3 Volt Intel[®] Advanced+ Boot Block Flash Memory

28F800C3, 28F160C3, 28F320C3, 28F640C3

Specification Update

November 2002

2. 28F320C3xC Reset Failure

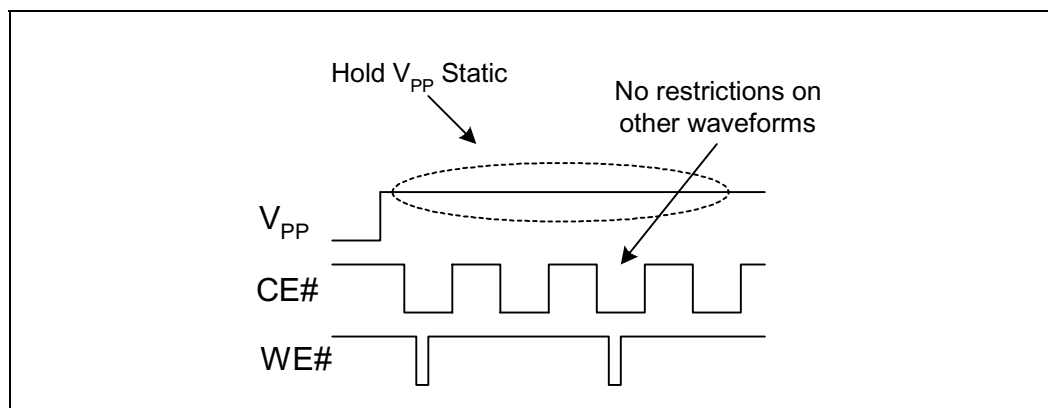
Problem: The 0.18 μ m 28F320C3xC devices can unintentionally reset under certain conditions where V_{pp} toggles.

4) Wait 2 ms after a V_{PP} transition to access the flash device, as shown here.

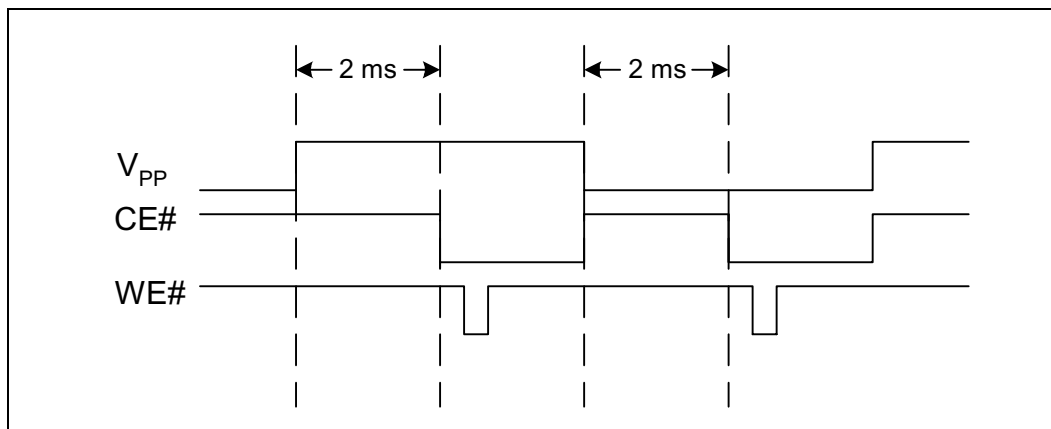
Implication: When the reset occurs, any command being executed is interrupted and the flash switches to read array mode.

- 1) Tie V_{pp} to V_{CC} ;
- 2) If the third and fourth digits on the top side FPO mark (third line) is equal or greater than “23”, then V_{CC} may be set from 2.7v to 3.3v. V_{CC} must not exceed 3.3v
- 3) Set V_{pp} to a static high or static low level as shown here; and

Figure 1. Workaround Placement

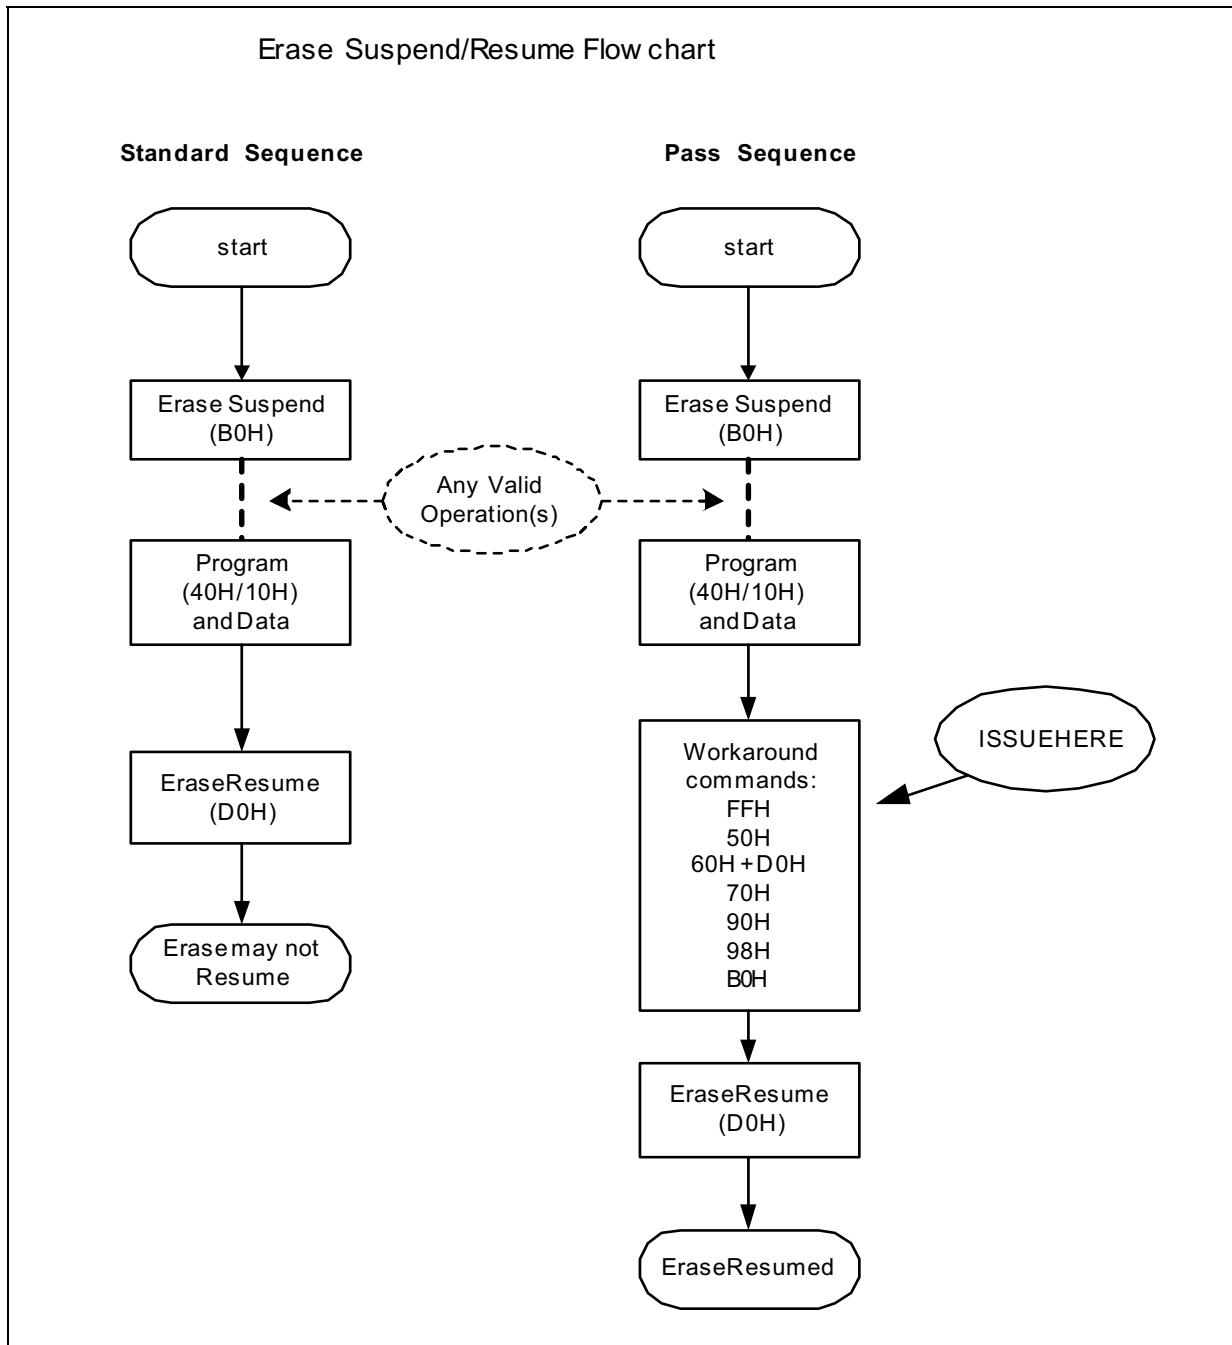
Problem: On the 0.18µm 28F160C3xC devices, a design anomaly was discovered. During an Erase-Suspend operation, if the Program (40H/10H) sequence is executed, under limited conditions the proceeding Erase Resume command (D0H) may not actually resume the device. No customers have reported failures in product applications. Customers who use any version of FDI (Intel Flash Data Integrator) software will not see this issue. If the Read Array command is issued prior to the Erase Resume command, users will not see the issue (typical in XIP applications).

Implication: The Resume Command (D0H) may be ignored by the device and will not correctly resume. The device will appear to remain in suspend (via status register). After a reset of the flash device the status register will clear. This failure has been recreated in a lab environment only.

1. If FDI (Intel Flash Data Integrator) software is used, users will not see the issue.
2. During an Erase-Suspend (B0H), user must issue any of the following commands after issuing the Program (40H/10H) and data sequence but before issuing the Erase-Resume (D0H) command.

5. 28F160C3xC and 28F640C3xC Lock/Unlock/Lock-Down Operation

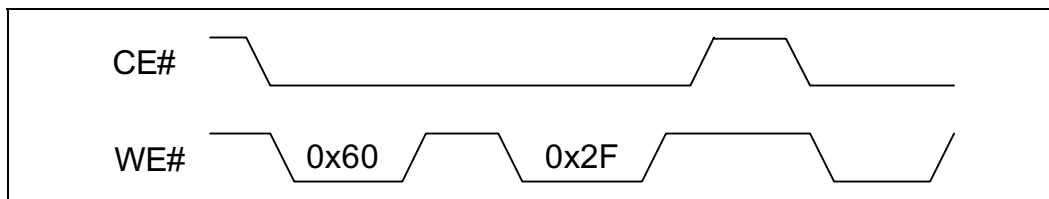
Problem: On the 16Mb and 64Mb 0.18µm devices, if CE# is deasserted after any block lock operation and before the next write sequence, the part may perform the same operation on additional blocks. (See waveform below.)

Implication: When CE# is deasserted after performing a block lock operation to a specific block and prior to the next write sequence, other blocks may perform the same operation.
